WATER PERMIT NO. 8946-3

SOUTH DAKOTA
WATER PERMIT NO. 8946-3

DUCKS UNLIMITED PROJECT JERRY MOENCH WETLAND LOCATED IN THE NW¹/₄ OF SECTION 3 TOWNSHIP 101N, RANGE 58W, 5TH P.M. HANSON COUNTY, SOUTH DAKOTA

Water Permit Application No. 8946-3 proposes to impound up to 85.4 acre-feet of runoff water by constructing two dams on a tributary to Bloom Creek. The application requests impoundment of sufficient water to maintain the water level to outlet elevations of 1,305 to 1,310 fmsl (NAVD88), respectively. For proposed dam #2, at the top of spillway elevation of 1,305 fmsl, approximately 21.5 acre-feet of water would be stored over 13.5 acres. For proposed dam #3, at the top of spillway elevation of 1,310 fmsl, approximately 64 acre-feet of water would be stored over 37.3 acres.

Figure 1: Map of the approximate watershed delineations above the proposed dams made using an IfSAR 5-meter spaced dataset (USGS, 2004)

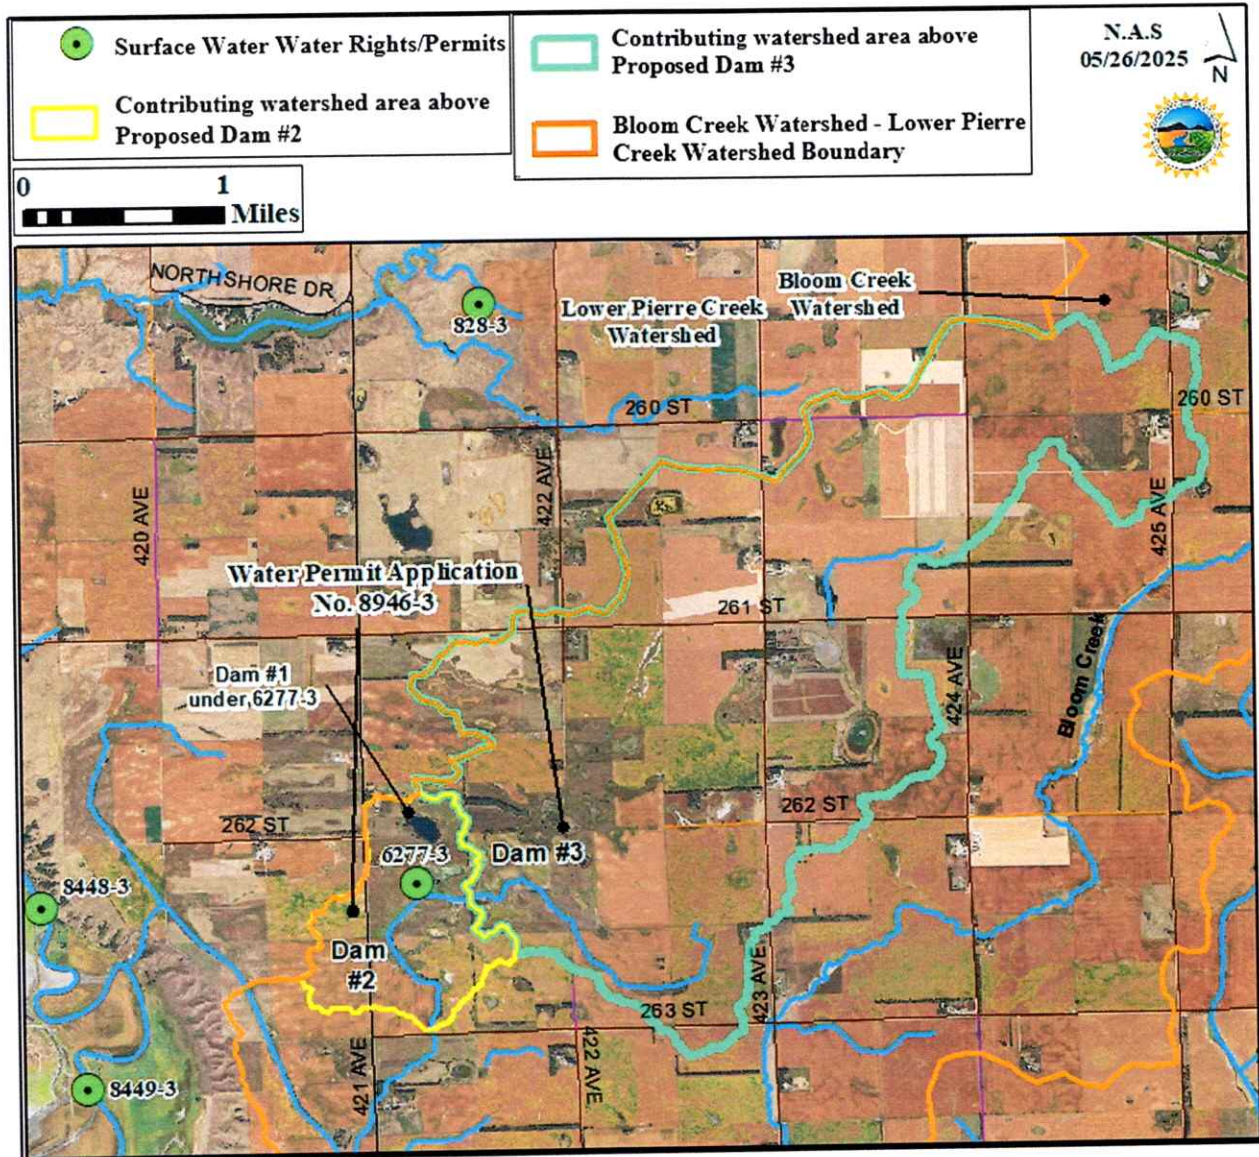
The watershed areas above the proposed dams were delineated using NRCS Engineering Tools for ArcGIS 10.3 (USDA-NRCS, 2024a). The elevation data used is an Interferometric Synthetic Aperture Radar (IfSAR) Digital Elevation Model (DEM) dataset with 5-meter grid spacing. A DEM is raster data of the bare ground (bare earth) topographic surface of the Earth excluding trees, buildings, and any other surface objects. Figure 1 displays the delineation of the contributing watershed areas above the proposed dams using IfSAR 5-meter spaced dataset. Within the Bloom Creek watershed, the contributing watershed to proposed dam #2 (labeled in Figure 1) was delineated to be approximately 488 acres. The contributing watershed to proposed dam #3 (labeled in Figure 1) was delineated to be approximately 3,908 acres.

Figure 2: Contributing watershed above proposed dam #2 delineated from 5-meter spaced IfSAR data to determine hydrologic soil groups as determined by soil map units (USDA-NRCS, 2025b)

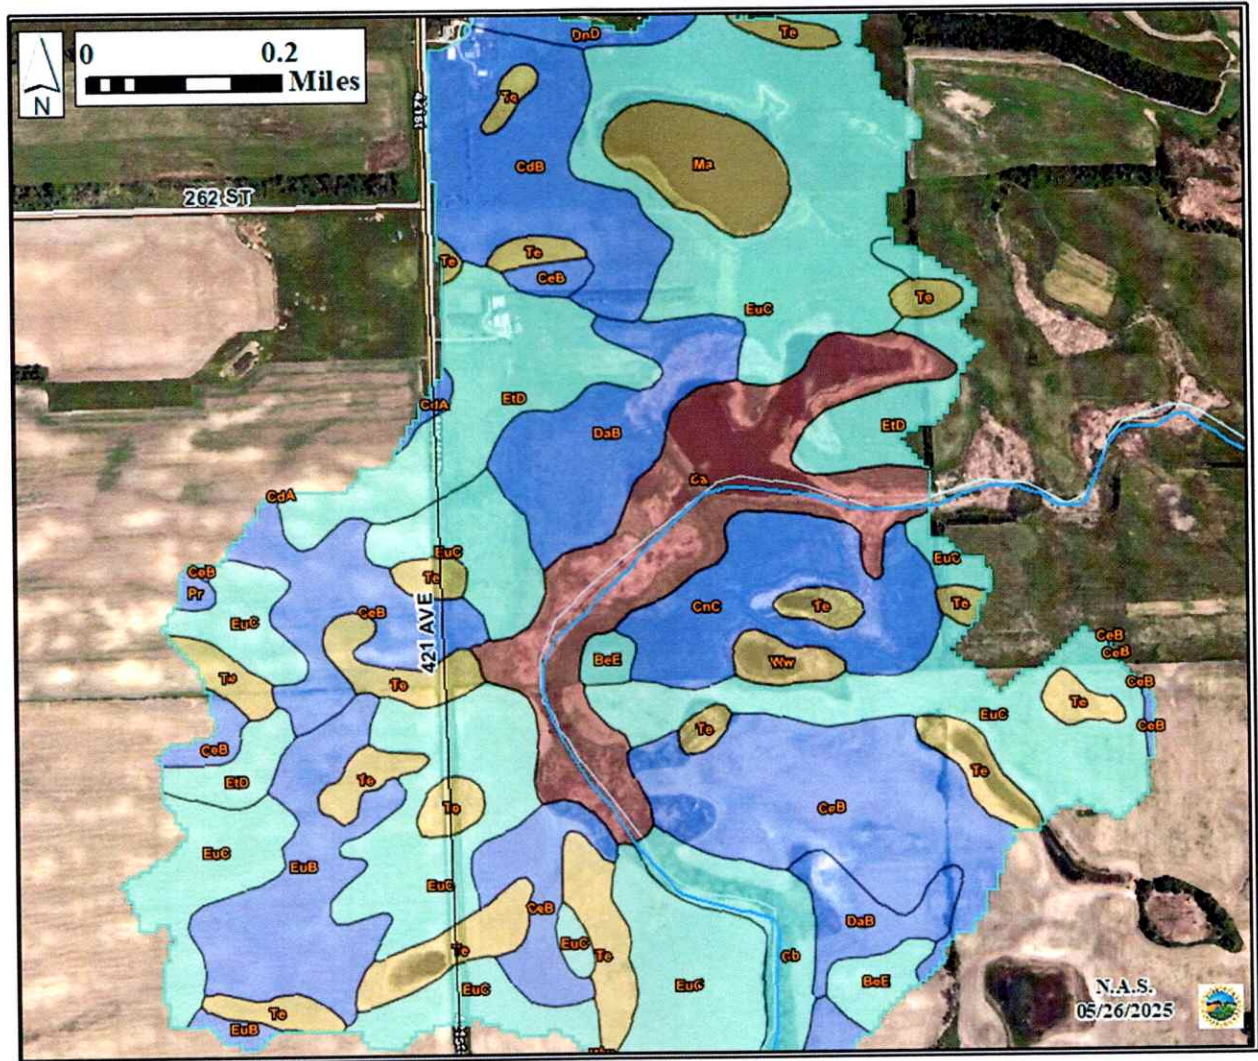
Table 1: Weighted average of hydrologic soil group ratios for cultivated land (without conservation treatment) used to determine curve number for proposed dam #2 (USDA-NRCS, 1984 and 2025b)

Figure 4. Plot of annual yield for proposed dam #2 from runoff against the probability of occurrence. Note that this plot and trendline is only applicable for this specific watershed location and area

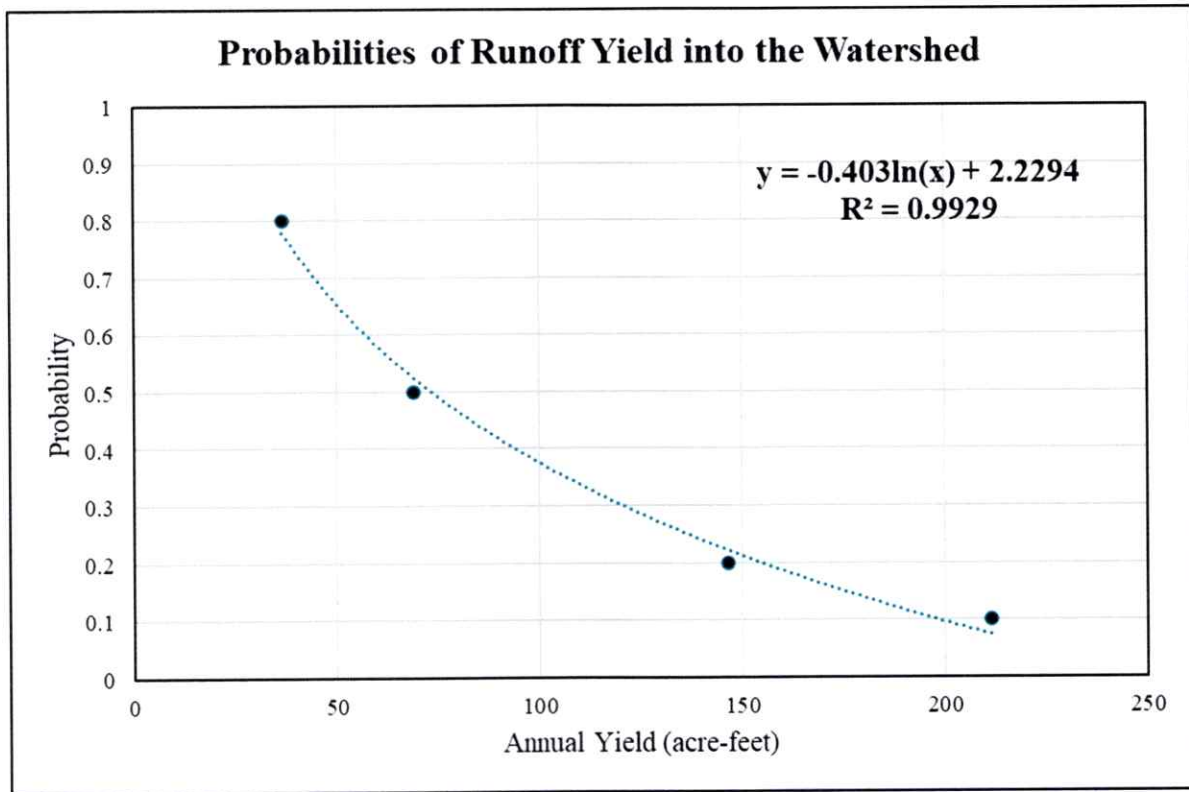
Water Permit Application No. 8946-3 proposes to capture runoff water that would otherwise contribute to Bloom Creek to be impounded in two proposed dams. To determine the probability of occurrence for the amount water in the catchment, the total runoff from Tables 3 and 4 were plotted against the probability of occurrence, shown in Figures 4 and 5. The closer an r square value is to 1, the data is better correlated, and there is more reliability in a trendline. Solving the trendline for a volume of 21.5 acre-feet and a runoff curve number of 85 (Figure 4), results in the estimated annual probability of the availability of annual yield fulfilling the proposed volume likely to occur around nine out of every 10 years (for proposed dam #2). Solving the trendline for a volume of 64 acre-feet and a runoff curve number of 83 (Figure 5), results in the estimated annual probability of the availability of annual yield fulfilling the proposed volume likely to occur at least nine out of every 10 years (for proposed dam #3). It should be noted that the drainage area above dam #3 has the potential to contribute runoff to dam #2.

Figure 5. Plot of annual yield for proposed dam #3 from runoff against the probability of occurrence. Note that this plot and trendline is only applicable for this specific watershed location and area

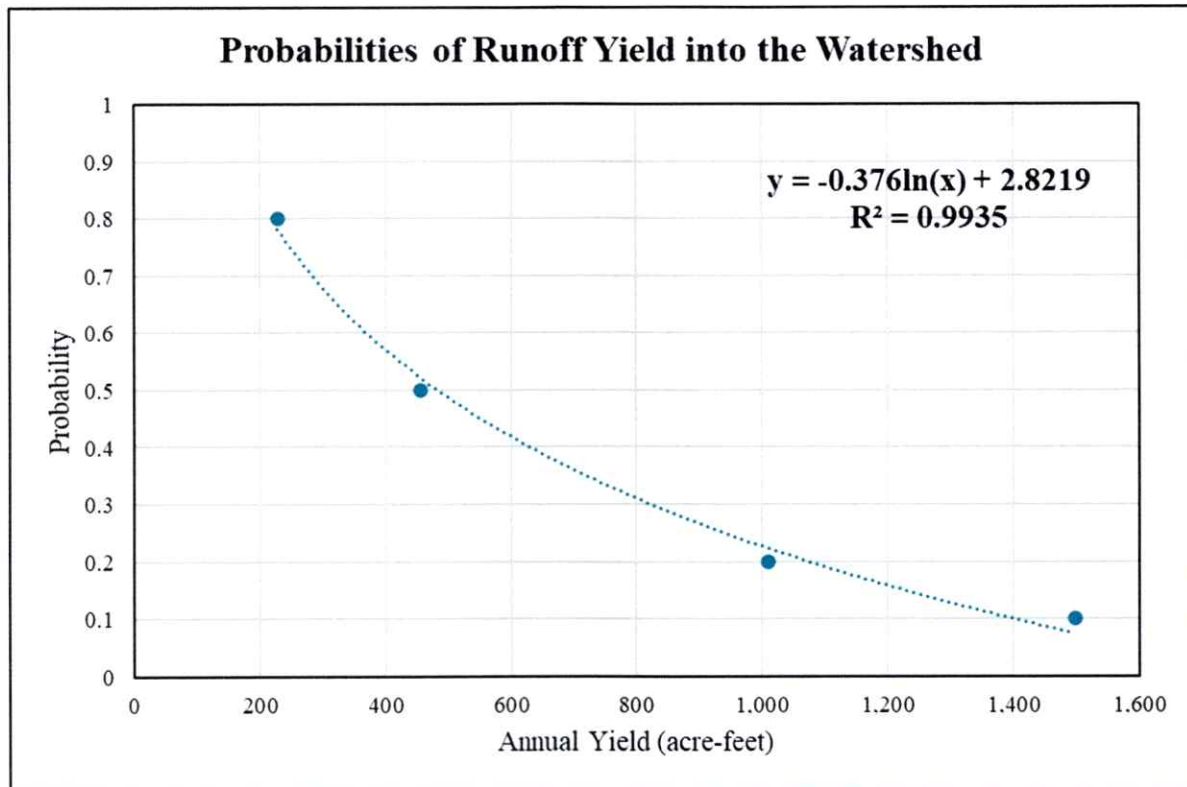
The application indicated the intent is to store captured runoff that would otherwise contribute to Bloom Creek in two proposed dams. Annual water losses from impoundments are mainly due to evaporation and seepage. The amount of surface runoff that is available for the two proposed dams will vary from year to year depending on the quantity and temporal distribution of precipitation as well as evaporative loss directly from the reservoir surfaces.
